## ADDENDUM NO. 2

Request for Proposal Call No. RFP2024-418  
**CONSTRUCTION OF THE FIELD HOCKEY & MULTISPORT TRAINING DOME,  
COMFORT STATION AT THE CASSIE CAMPBELL COMMUNITY CENTRE**

This Addendum forms part of the Bid/Proposal Document.

drawing title  
**ARTIFICIAL TURF  
 BASE PAVING PLAN**

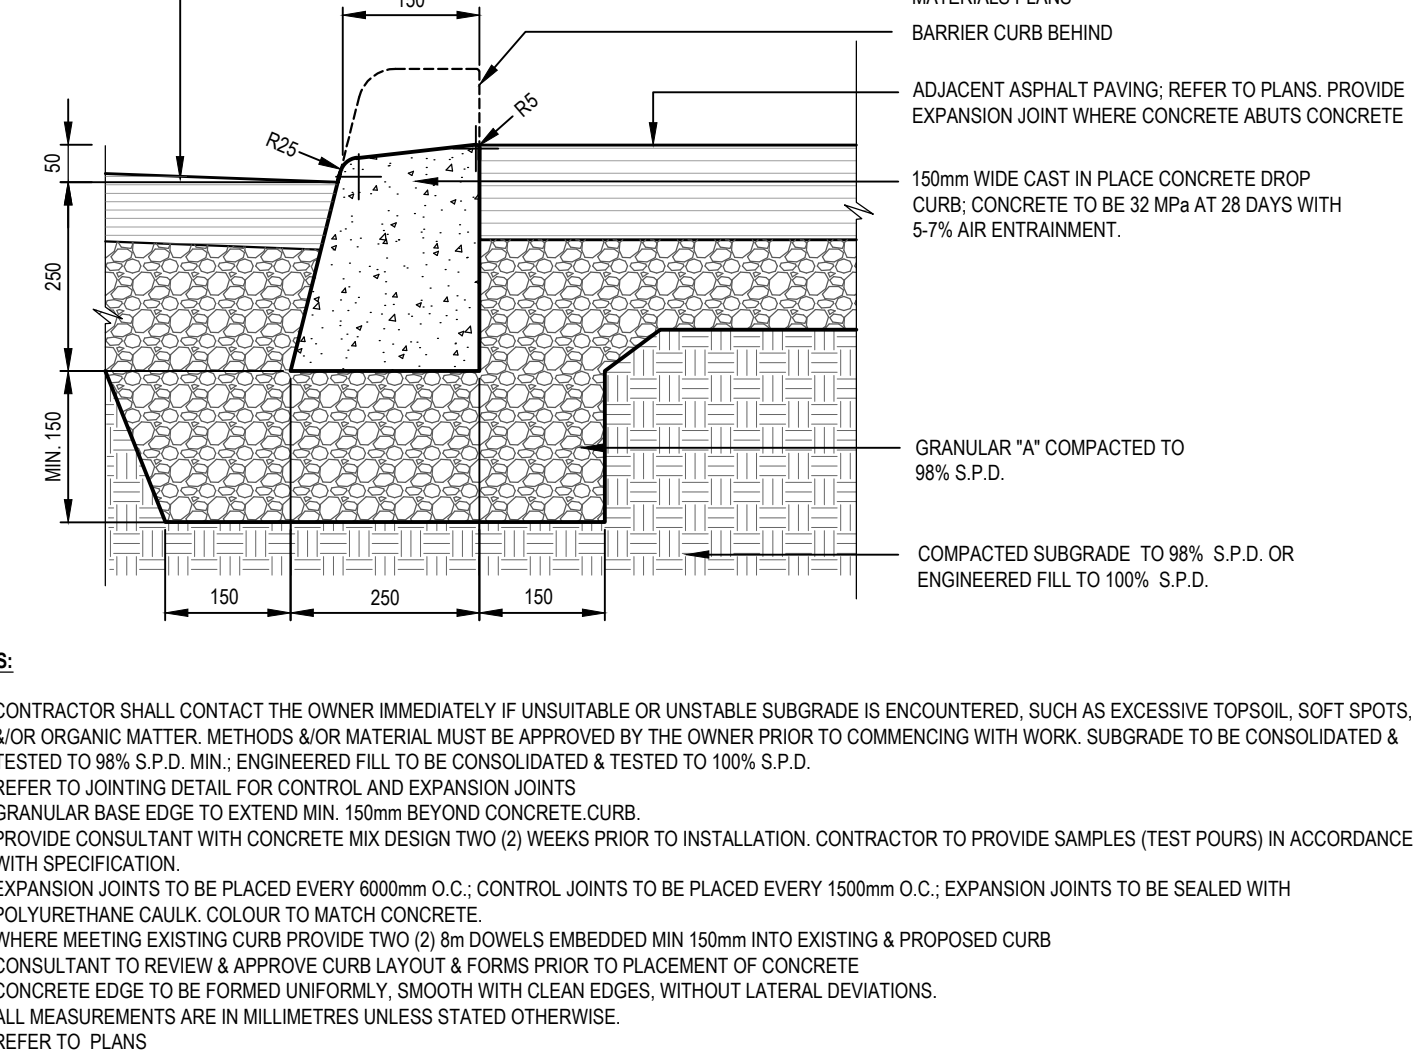
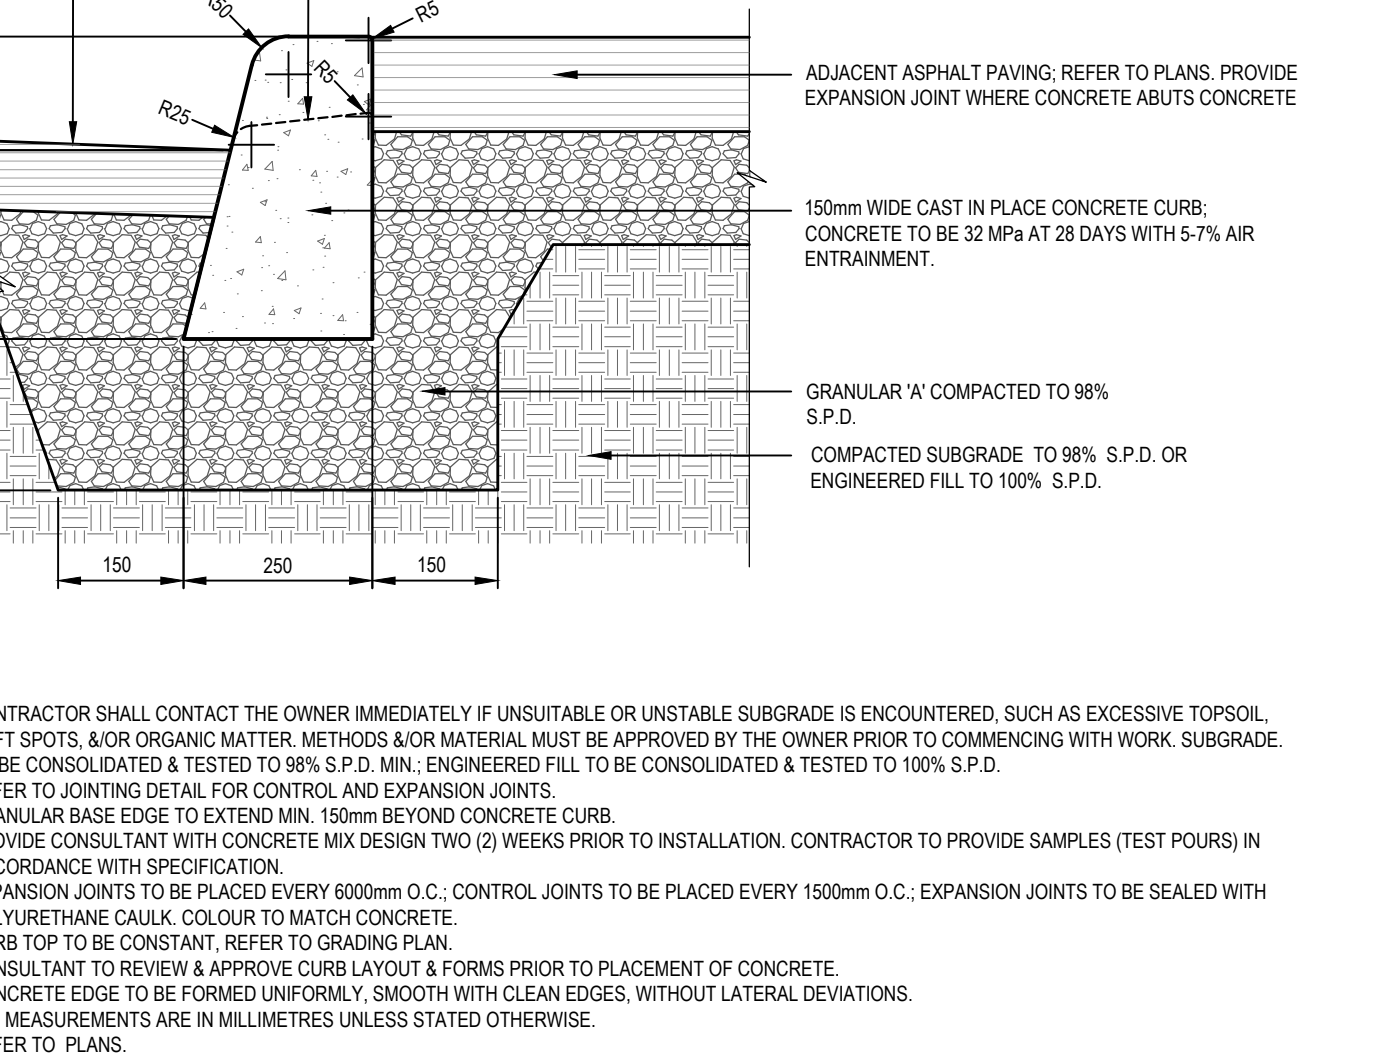
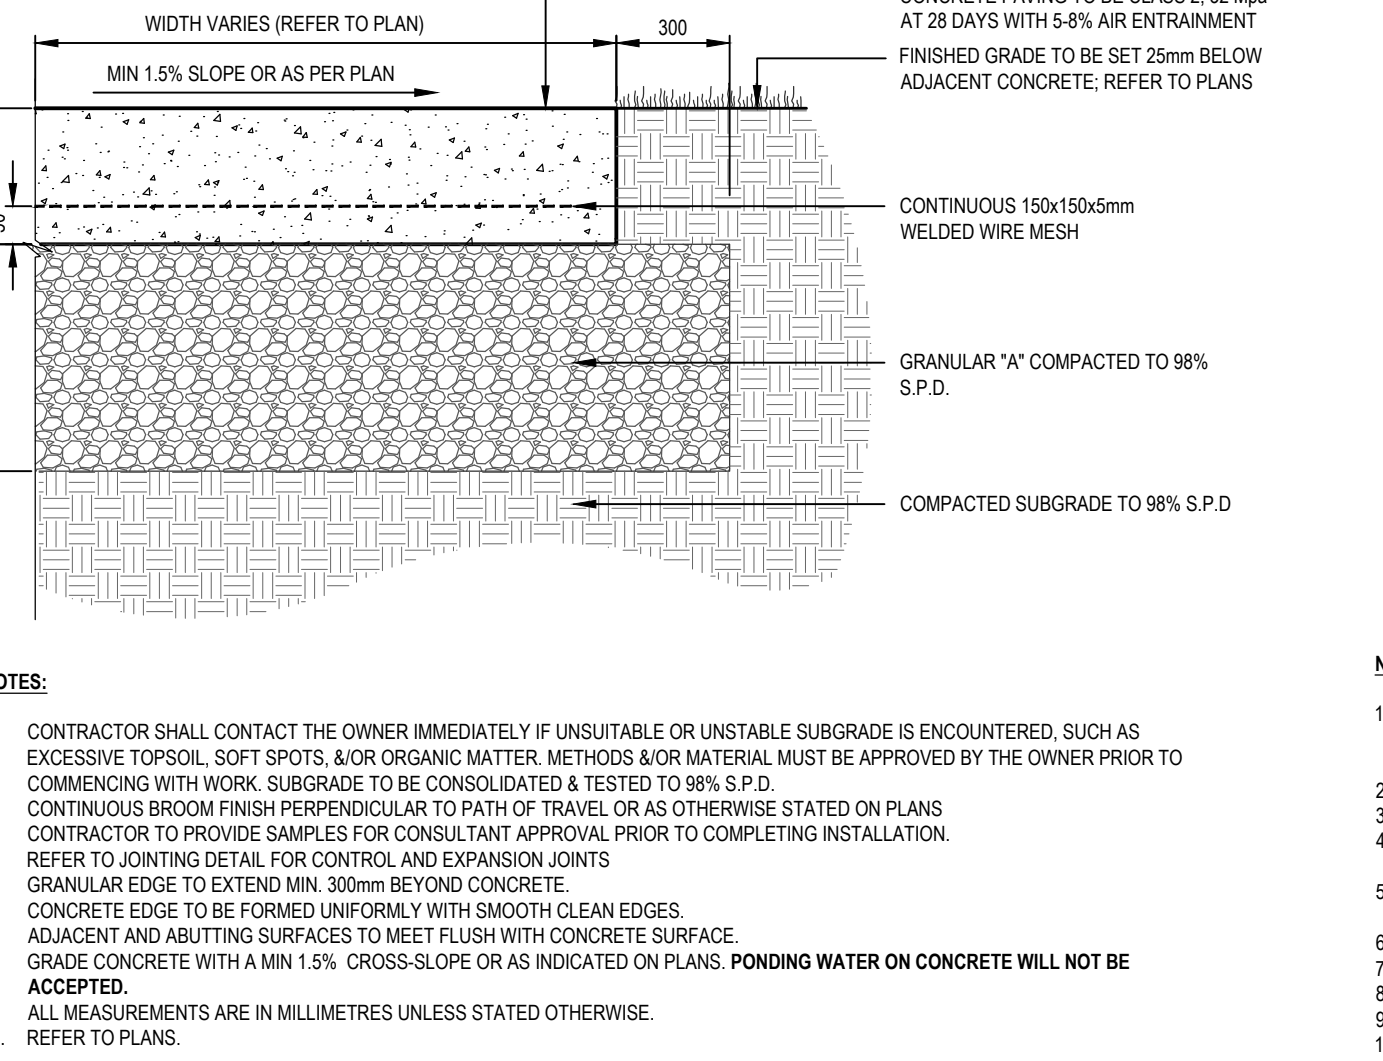
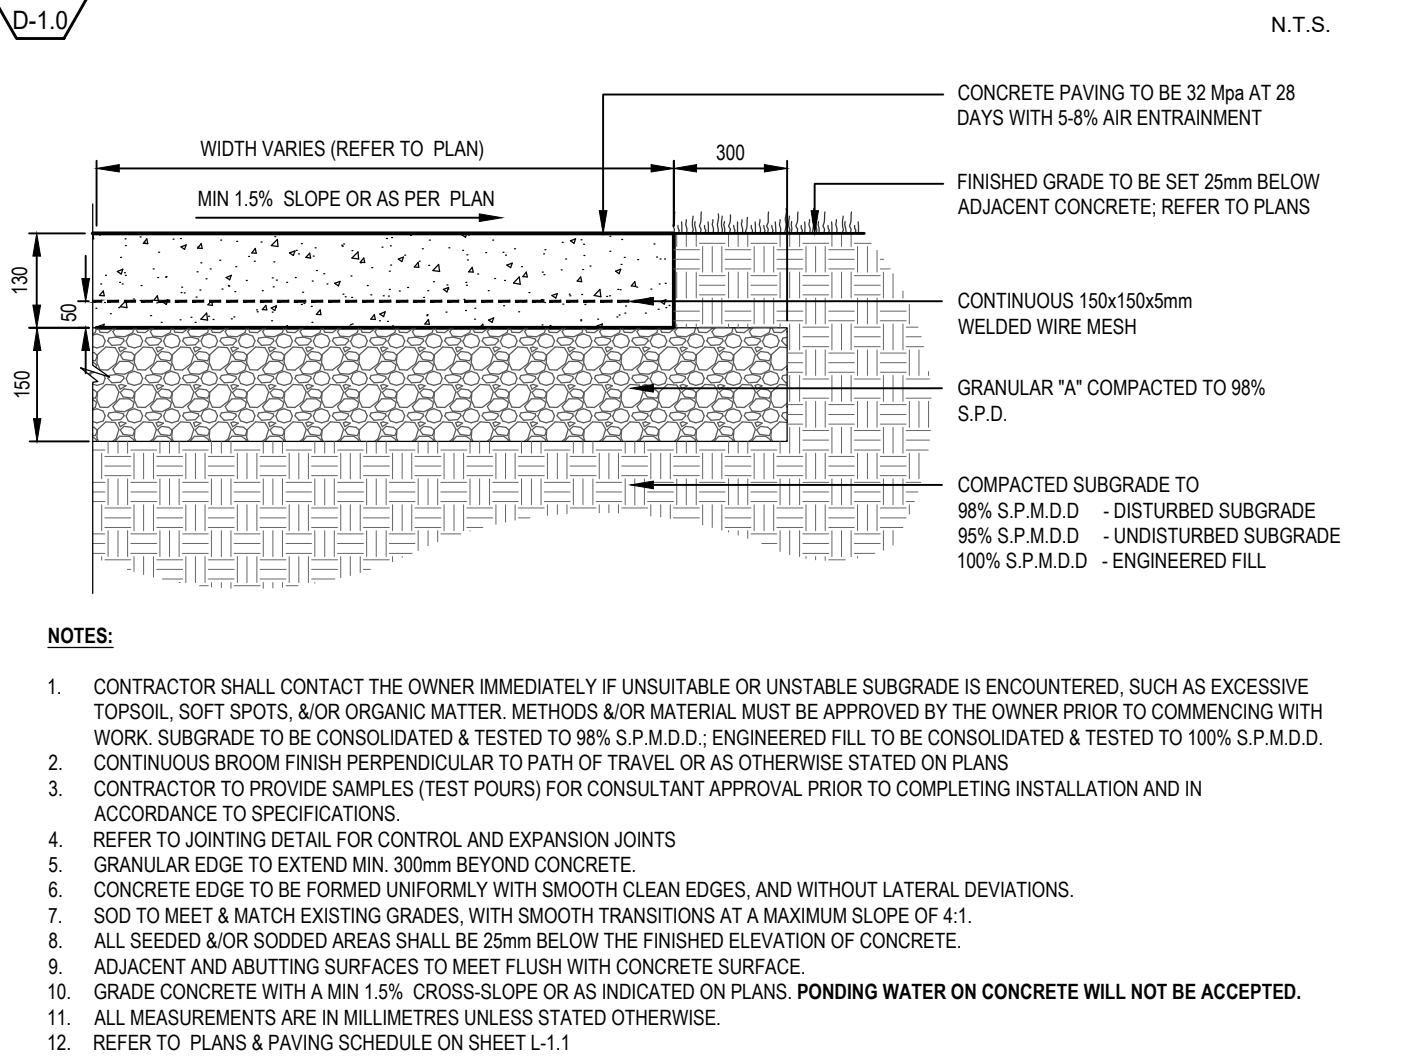
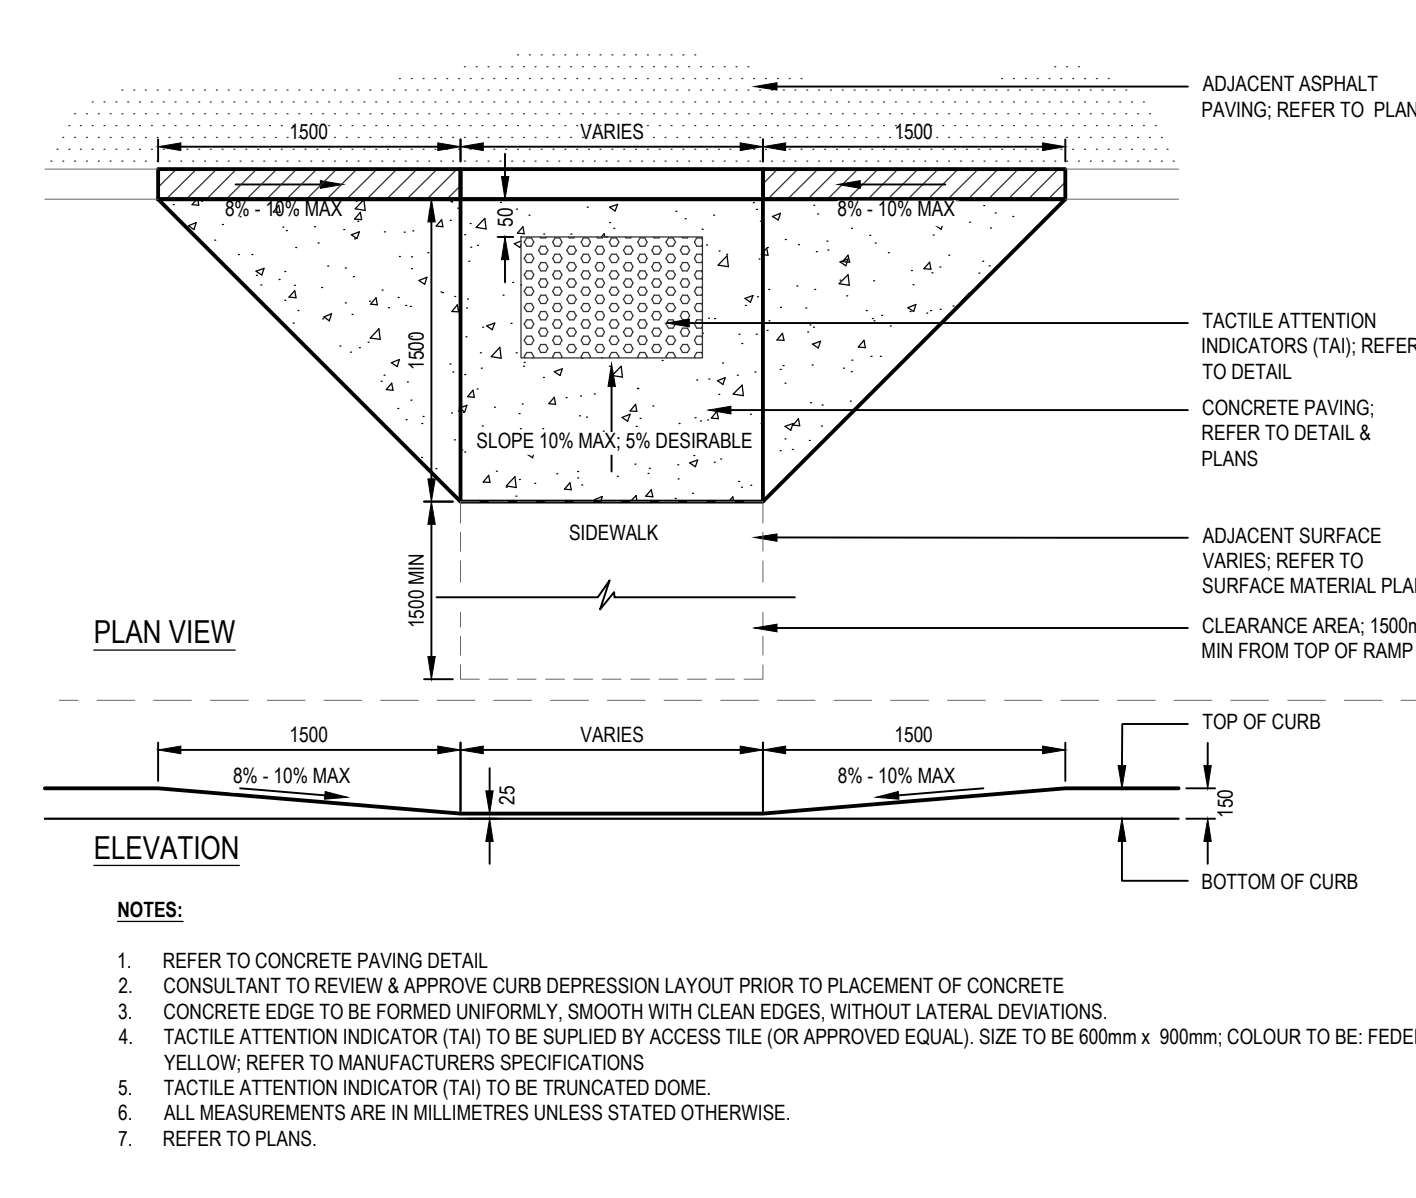
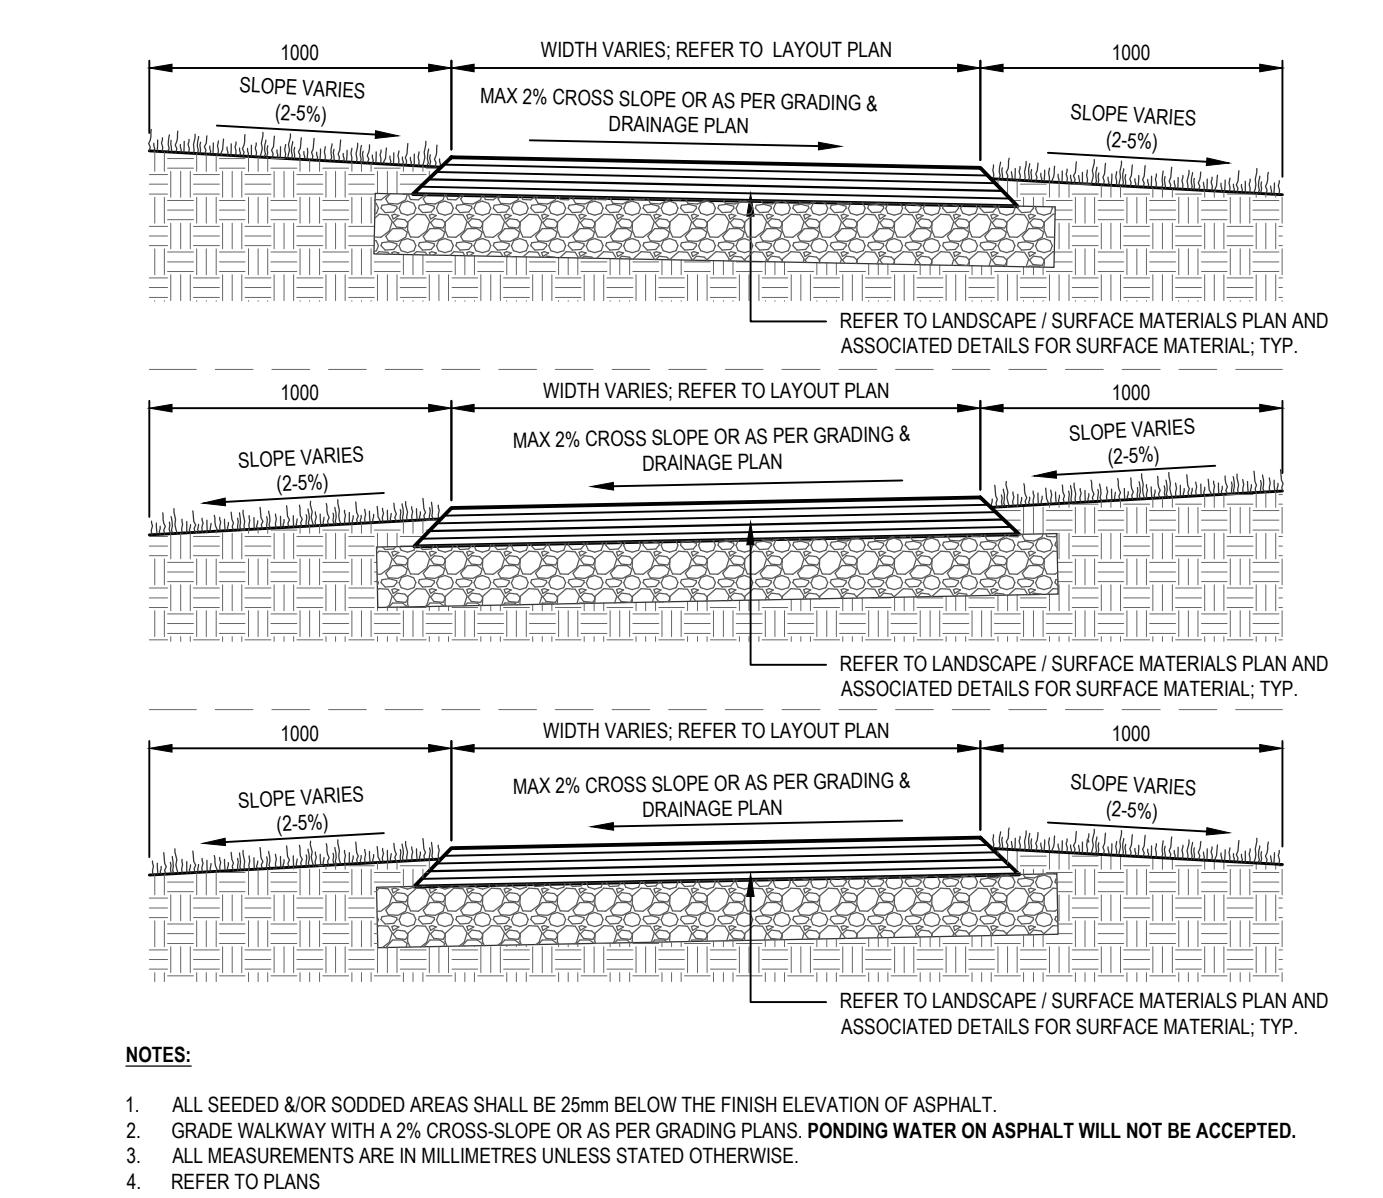
**Q22: We are not sure of the limits of asphalt and concrete paving below the artificial turfs. Can a detailed drawing be provided? We also noticed player benches are anchored to concrete pad. Can concrete pad limits be shown on plan view drawings?**

A22: Refer to new drawing L-1.1: Artificial Turf Base Paving Plan.
